Access Compliance Report

Public Rights-of-Way

(Island Curb Cuts)

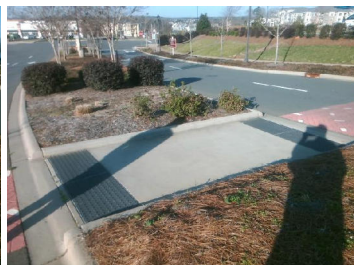
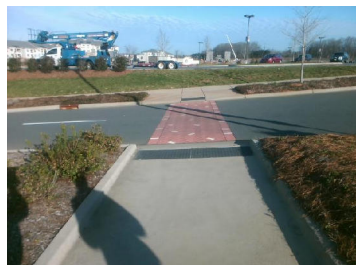
Intersection ID: 10032944	Main Street: NEW_FASHION_WY	Cross Street: N/A	Location: SW
ADA ID: D942FBD22417	Curb Cut Type: MedianRefuge2	Initial Pass/Fail: Fail	Overall Compliance: No
Severity Score: 12.5			
Codes/Mitigation Info/Possible Solution		Field Measurements/Component Compliance

Remove & Replace Entire Refuge.
